Section 7.0: Standards for Compliance

CIRCULATION DIAGRAM

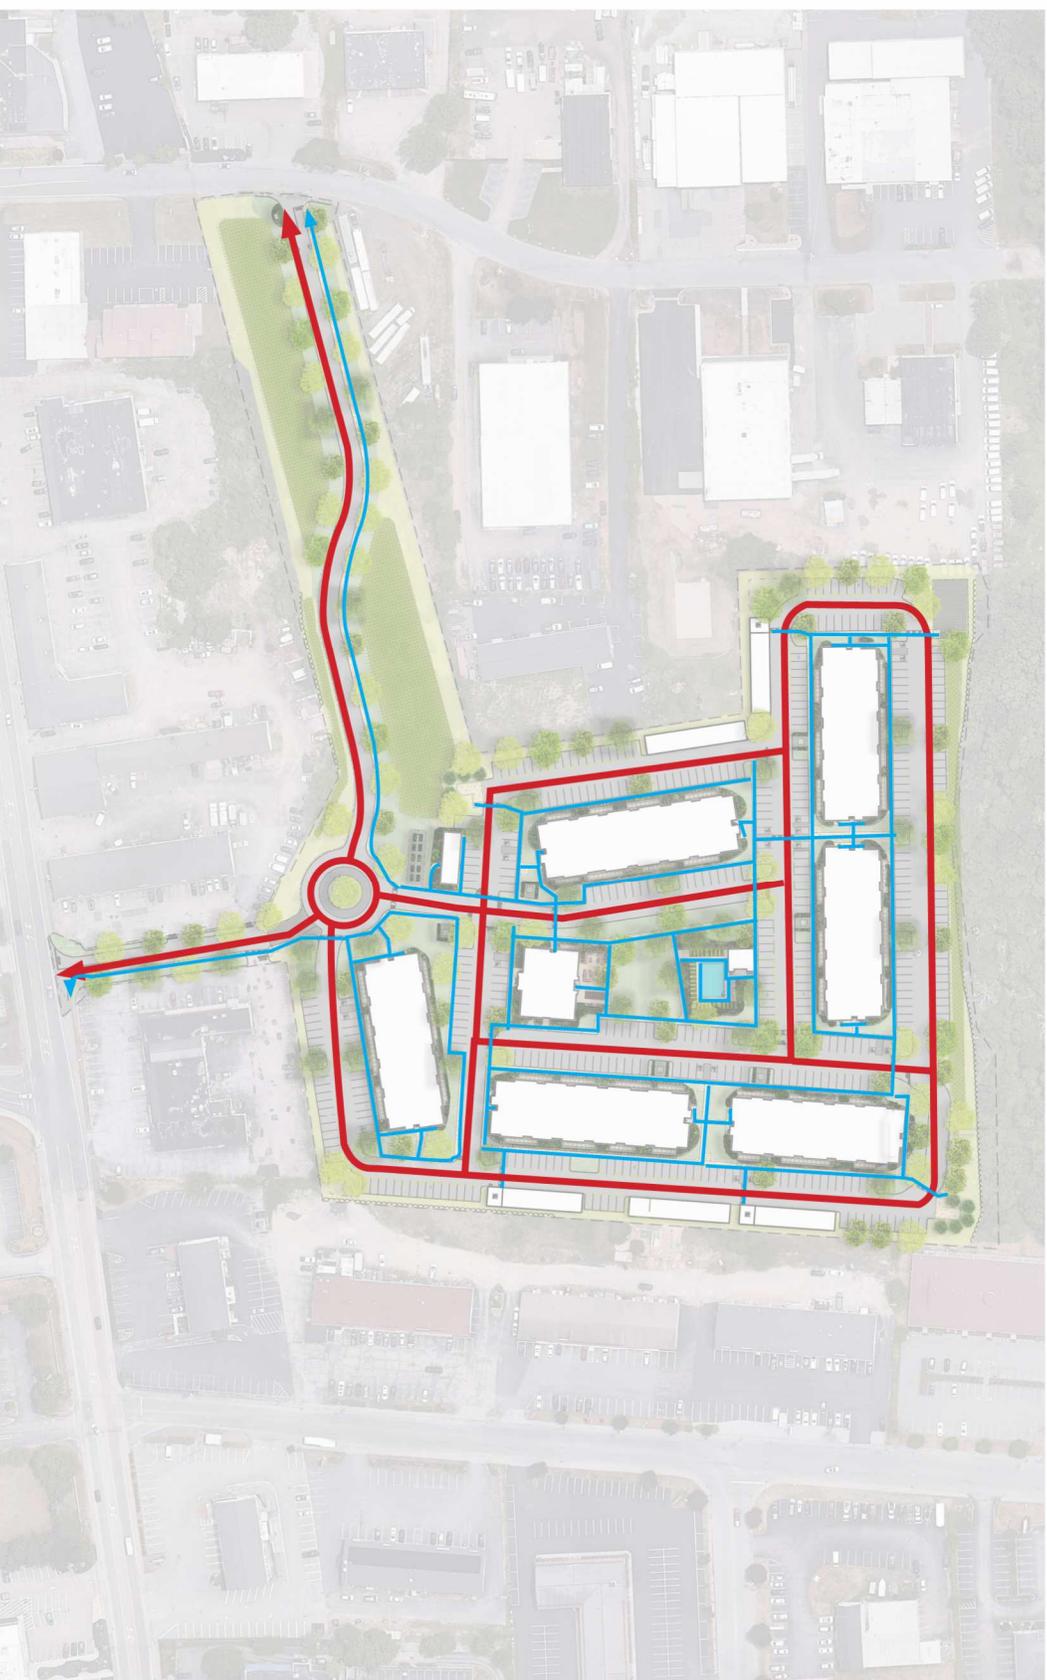
1. **Curb-cuts and Driveways** - The number of curb cuts shall be limited to two (2) per street line. Curb cuts shall not exceed twenty-five (25) feet. All driveways shall be designed to afford motorists exiting to roads with safe sight distance. The proposed development shall assure safe interior circulation within its site by separating pedestrian and vehicular traffic. To the extent practicable, access to businesses shall be provided via one of the following:
 - A. A common driveway serving adjacent lots or premises
 - B. An existing side street; or,
 - C. A cul-de-sac or loop road shared by adjacent lots or premises.

The project will have 1 curb cut at George Leven Drive and 1 curb cut off Kelley Blvd. The curb cuts are 50 ft wide and 71 ft wide respectively. Curb cut dimensions were taken from tie-in points at existing right of way. A Site Circulation Plan was reviewed at the 10/17/24 Planning Board meeting illustrating the pedestrian circulation throughout the site as well as vehicular traffic circulation. An updated site circulation plan is included as an attachment to this memo.
